ATTACHMENT 3

Proposed Changes to the Technical Specifications
for Implementing the New Requirements of 10CFR20

TSI - 044 - TSI - 053

FIGURE 5.1-4
UNRESTRICTED AREA* AND SITE BOUNDARY FOR RADIOACTIVE LIQUID EFFLUENTS

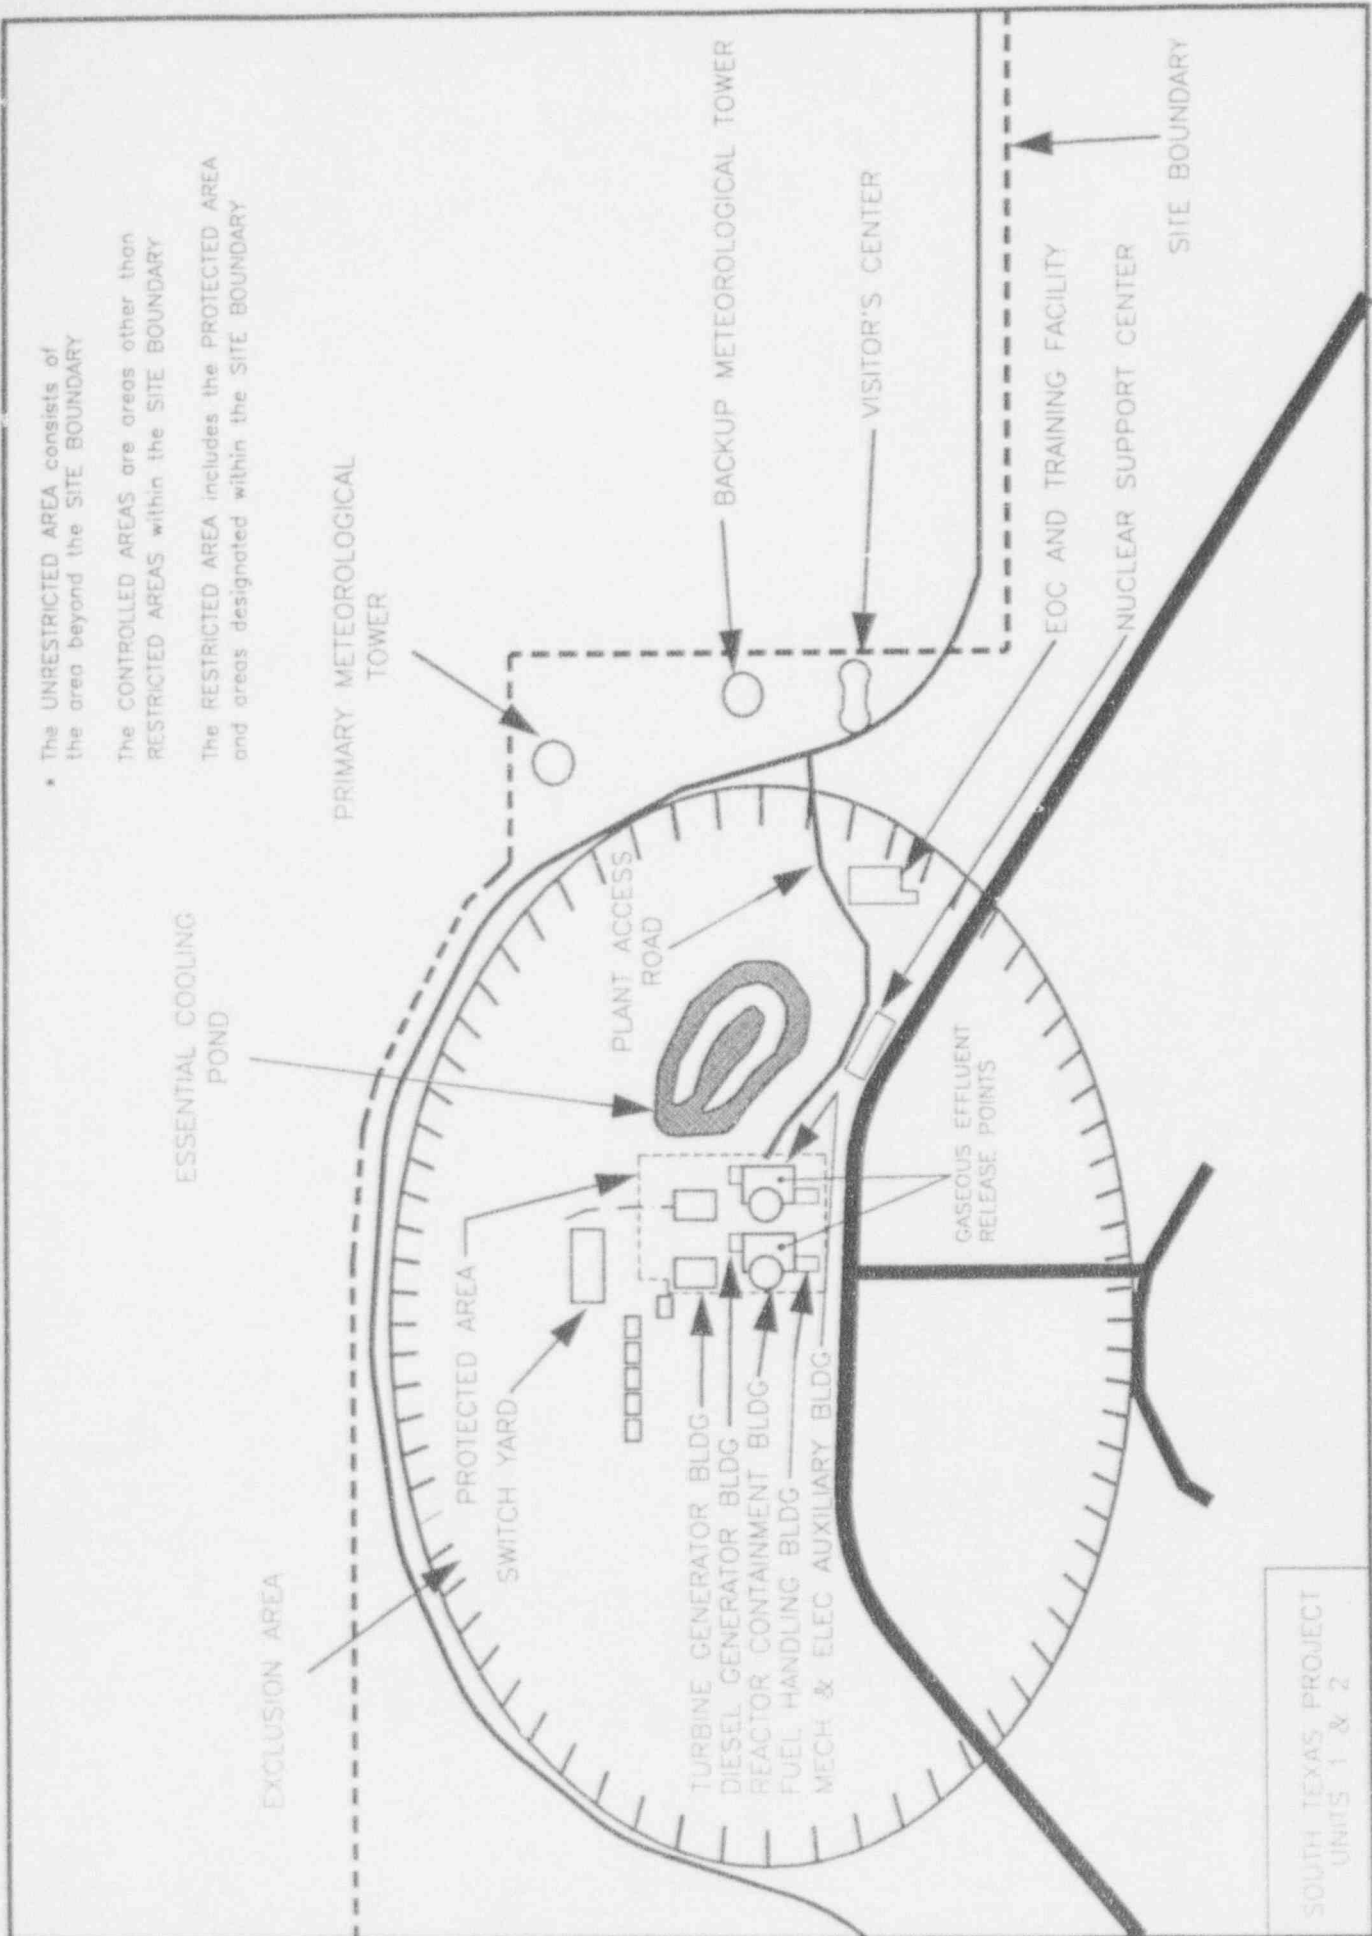
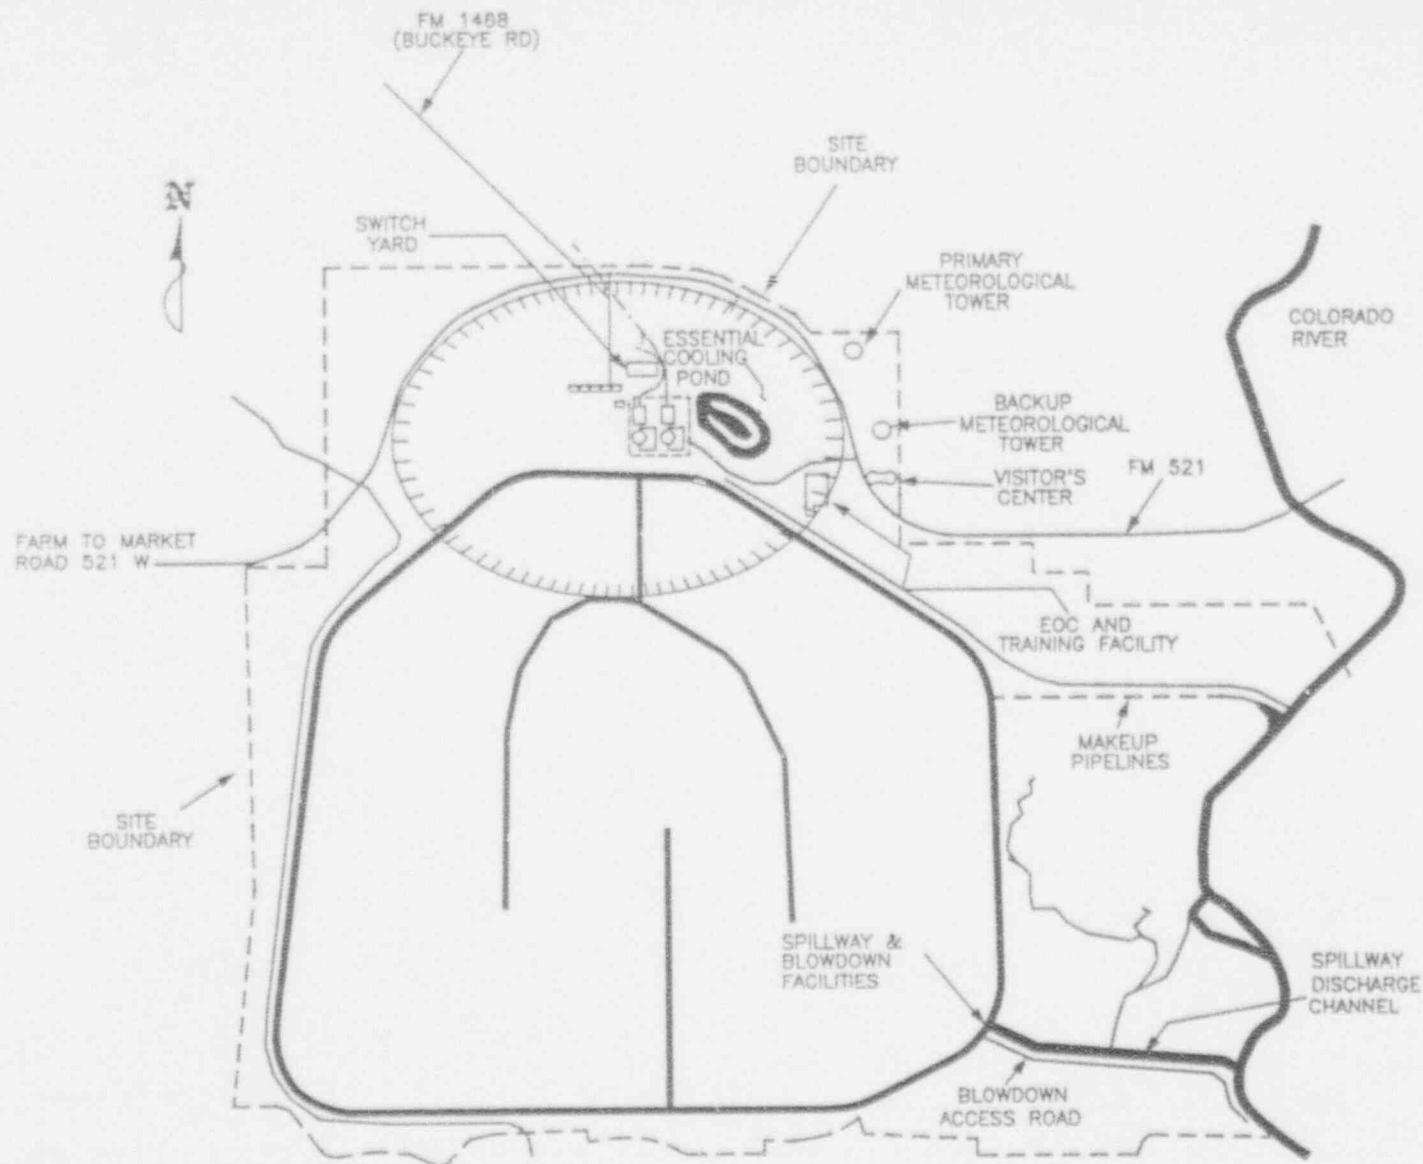
* The UNRESTRICTED AREA consists of
the area beyond the SITE BOUNDARY.

1.39 UNRESTRICTED AREA means any area access to which is neither limited nor controlled by the licensee.
